## Product Change Notice

Add ASE-SG as a 2nd source Final Test site

BCM89530B1BPBG

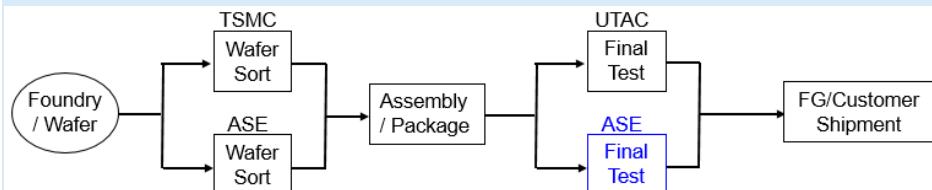
Electrical Final Testing (FT) is currently performed on this product at UTAC (Singapore). Broadcom will add ASE-SG (Singapore) as a 2nd source for FT. There is no change to the Foundry or Assembly locations or processes for this PCN- see updated flow below.
